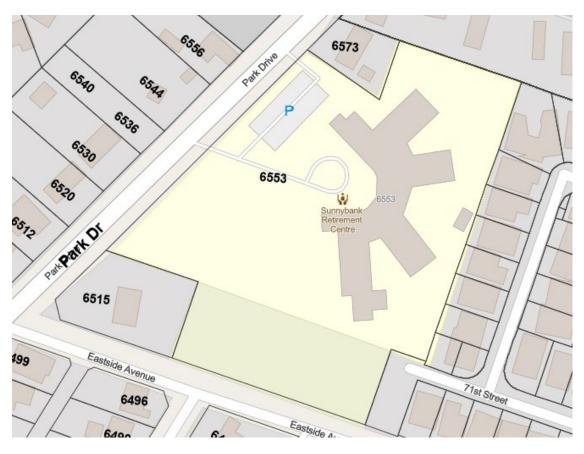
10. Can you provide up-to-date site surveys, including the legal boundary survey and topographical survey

Check out the RDOS website. The property leased by the Town is the portion in light green below.
